Access Compliance Report

Public Rights-of-Way

(Curb Ramps)

Intersection ID: 16823	Main Street: MILL_RUN_DR	Cross Street: SELWYN_FARMS_LN	Location: SE
ADA ID: 18F0ABBFE25C	Ramp Type: PerpDiag	Initial Pass/Fail: Fail	Overall Compliance: No
Severity Score: 21.25			
Codes/Mitigation Info/Possible Solution		Field Measurements/Component Compliance

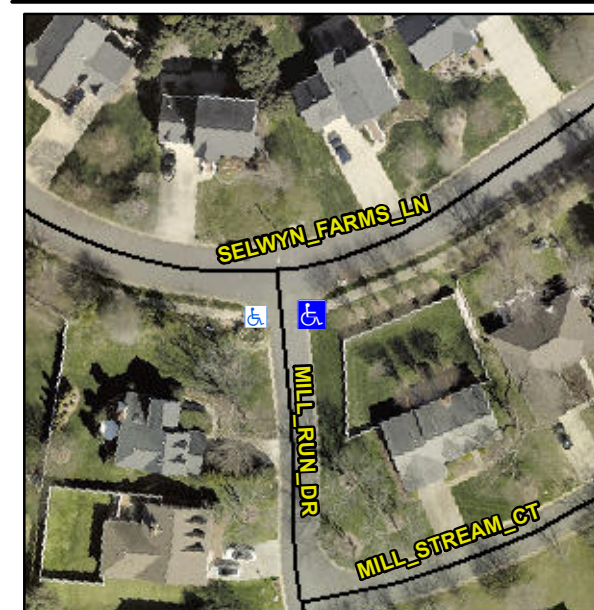
R304.5.1, R304.5.3

Compliance	Description	Data	Compliance	Description	Data
N/A	Ramp Length (in)	38.0	Yes	Ramp Slope (%)	6.3
No	Ramp Width (in)	47.0	No	Ramp XSlope (%)	5.2
N/A	Flare Type LT	N/A	N/A	Flare Type RT	N/A
N/A	Flare Slope LT (%)	N/A	N/A	Flare Slope RT (%)	N/A
N/A	Flare Traversable LT?	N/A	N/A	Flare Traversable RT?	N/A
N/A	Landing Length (in)	N/A	N/A	DWS Provided?	N/A
N/A	Landing Width (in)	N/A	N/A	DWS Contrast?	N/A
N/A	Landing Slope (%)	N/A	N/A	DWS Length (in)	N/A
N/A	Landing X Slope (%)	N/A	N/A	DWS Full Width?	N/A
N/A	Landing Curb? (Y/N)	N/A	N/A	DWS Offset (in)	N/A
N/A	Shared Landing?	N/A			
N/A	Gutter Ponding?	N/A	N/A	Gutter Slope (%)	N/A
N/A	Gutter Lip Ht (in)	N/A	N/A	Gutter X Slope (%)	N/A
N/A	Painted X Walk1?	No	N/A	Painted X Walk2?	No
	X Walk 1 Direction	To N		X Walk 2 Direction	To W
N/A	X Walk 1 Width (in)	N/A	N/A	X Walk 2 Width (in)	N/A
	X Walk 1 Slope (%)	6.0		X Walk 2 Slope (%)	3.6
	X Walk 1 X Slope (%)	0.9		X Walk 2 X Slope (%)	5.1

N/A	Ramp inside XWalk1?	N/A	N/A	Ramp inside XWalk2?	N/A
	Road Slope (%)	2.8	N/A	Clear Space?	N/A
	Road X Slope (%)	5.5	N/A	Clear Space to XWalk (in)	N/A
N/A	Any Obstructions?	N/A	N/A	Storm Grate/Utility Hazard?	N/A
	Obstruction Type			Storm Grate/Utility Type	
		N/A			N/A
			Yes	Surface Condition? (G/P)	Good

Remove & Replace Curb Ramp With Two New Directional Ramps or Equivalent.
